# Access Compliance Report

## Public Rights-of-Way

### (Curb Ramps)

Intersection ID: 45983	Main Street: MASON_MILL_PL	Cross Street: WOODBOURNE_LN	Location: S
ADA ID: 0BF233E5471C	Ramp Type: Perp	Initial Pass/Fail: Fail	Overall Compliance: No
		Severity Score: 25

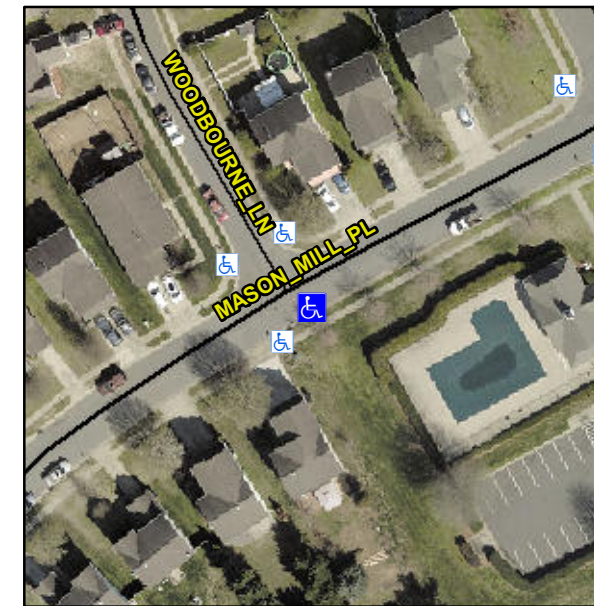
**Not Found, R304.5.3**

Compliance	Description	Data	Compliance	Description	Data
N/A	Ramp Length (in)	47.0	Yes	Ramp Slope (%)	7.3
Yes	Ramp Width (in)	48.0	No	Ramp XSlope (%)	8.8
N/A	Flare Type LT	N/A	N/A	Flare Type RT	N/A
N/A	Flare Slope LT (%)	N/A	N/A	Flare Slope RT (%)	N/A
N/A	Flare Traversable LT?	N/A	N/A	Flare Traversable RT?	N/A
N/A	Landing Length (in)	N/A	N/A	DWS Provided?	N/A
N/A	Landing Width (in)	N/A	N/A	DWS Contrast?	N/A
N/A	Landing Slope (%)	N/A	N/A	DWS Length (in)	N/A
N/A	Landing X Slope (%)	N/A	N/A	DWS Full Width?	N/A
N/A	Landing Curb? (Y/N)	N/A	N/A	DWS Offset (in)	N/A
N/A	Shared Landing?	N/A			
N/A	Gutter Ponding?	N/A	N/A	Gutter Slope (%)	N/A
N/A	Gutter Lip Ht (in)	N/A	N/A	Gutter X Slope (%)	N/A
N/A	Painted X Walk1?	No	N/A	Painted X Walk2?	N/A
	X Walk 1 Direction	To N		X Walk 2 Direction	N/A
N/A	X Walk 1 Width (in)	N/A	N/A	X Walk 2 Width (in)	N/A
	X Walk 1 Slope (%)	2.3		X Walk 2 Slope (%)	N/A
	X Walk 1 X Slope (%)	3.6		X Walk 2 X Slope (%)	N/A

**Remove & Replace Entire Ramp.**
